REMARKS

Amendments to the Drawings

In the Drawings:

MARK UP COPY

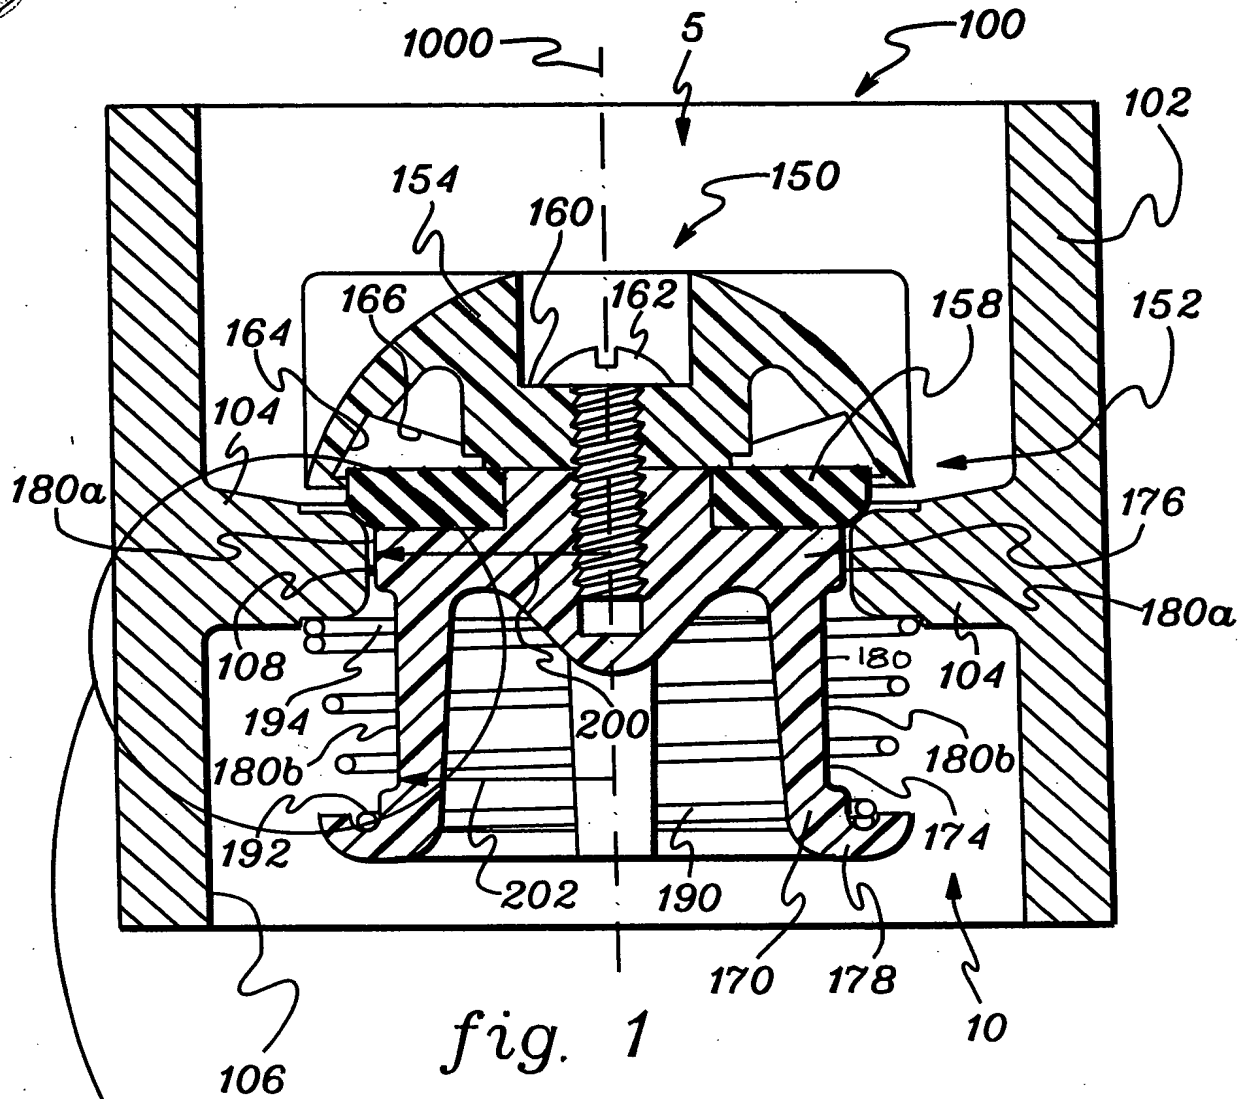
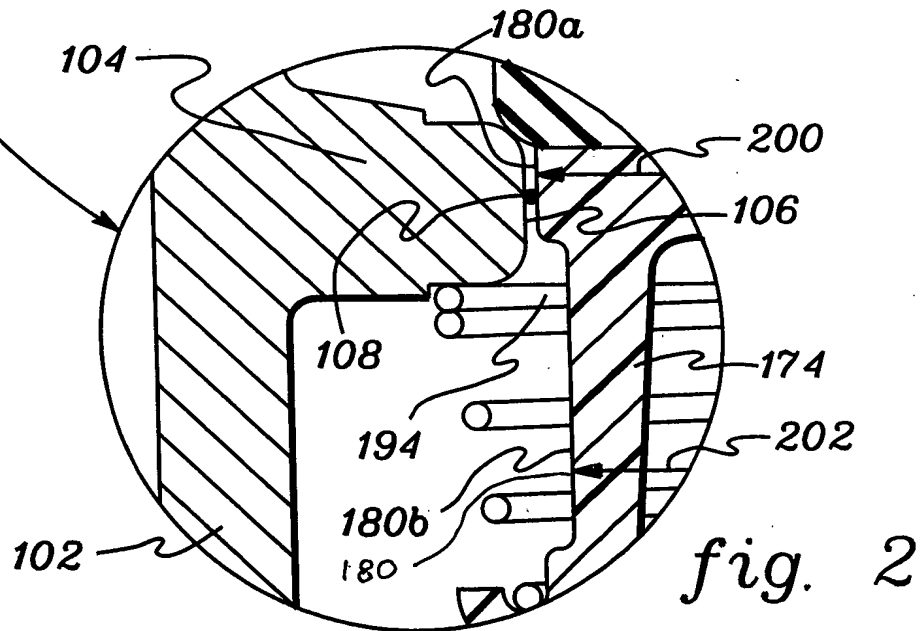
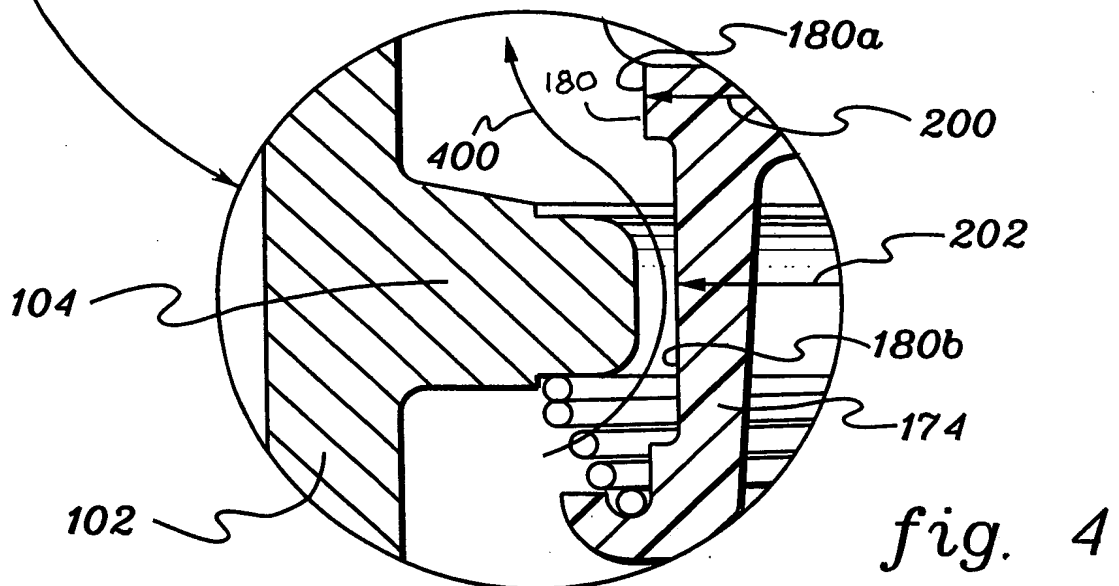
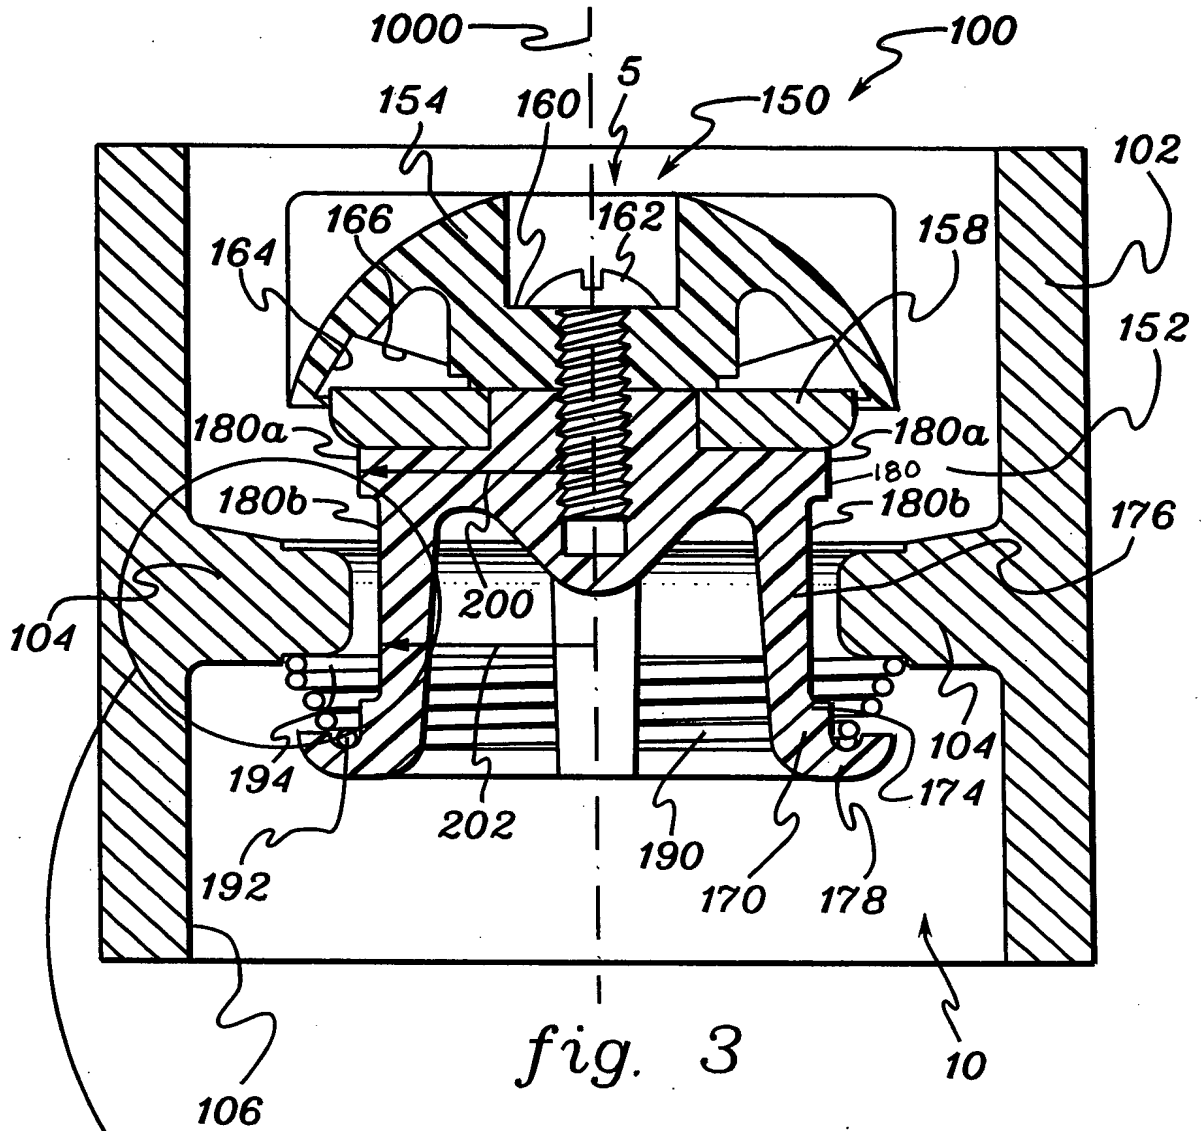
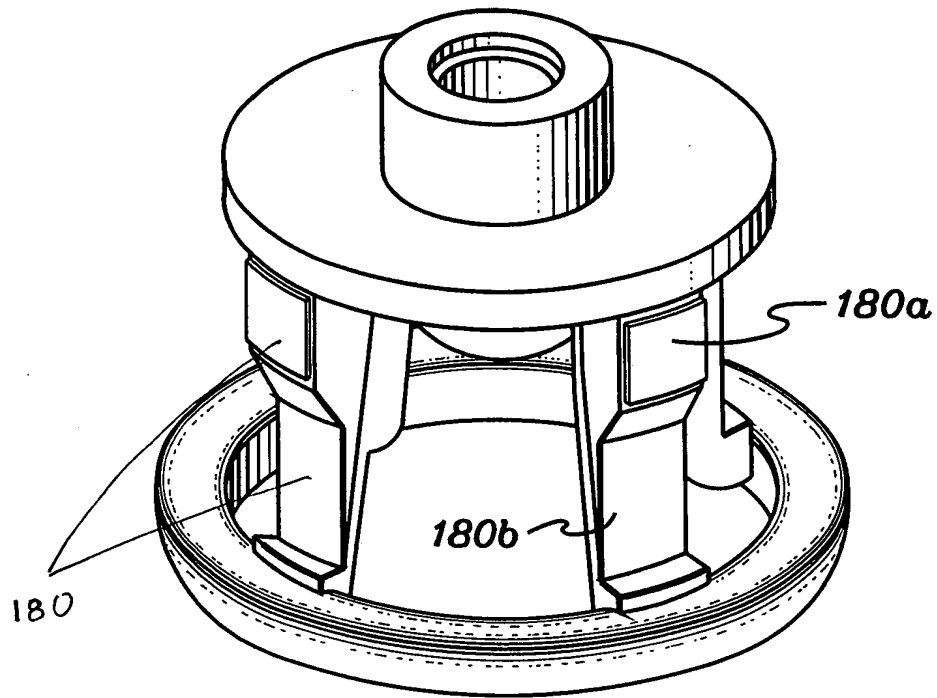
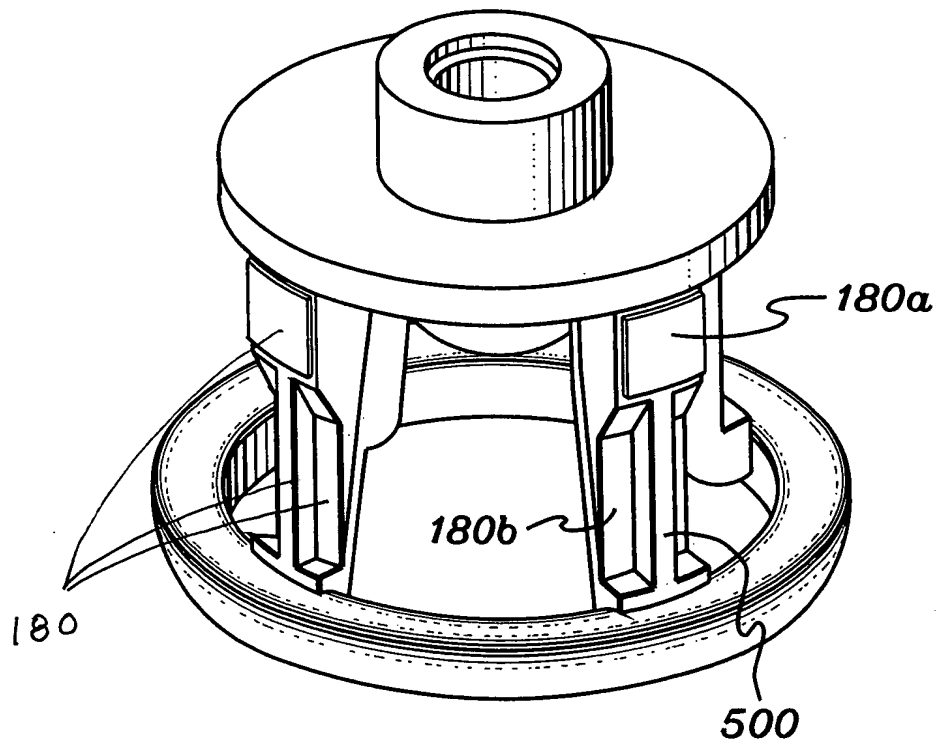
In the second Office Action, the drawings were rejected under 37 C.F.R. §1.83(a) because they fail to show the outer peripheral surface, 180, as described in the specification. Applicant has corrected this informality identified by the Examiner and submits Replacement Sheets 1-3 comprising FIGS. 1-5B attached hereto as Appendix A and labeled as “Replacement Sheet” (in response to the Notice of Non-Complaint Amendment), each including reference to outer peripheral surface 180, which includes both outer peripheral surfaces 180A and 180B. A marked up copy of the drawing sheets in red ink is also attached hereto and labeled as “Mark Up Copy” for easy reference to the revisions made. No new matter has been added to the application by the amendment to the drawings. Accordingly, withdrawal of this objection and approval of the drawings is respectfully requested.

Please replace the originally presented drawing sheets 1-3 containing Figures 1-5B, attached hereto and labeled as “Mark-Up Copy”, with the replacement drawing Sheets 1-3 containing Figures 1-5B, attached hereto in Appendix A and labeled as “Replacement Sheet.”
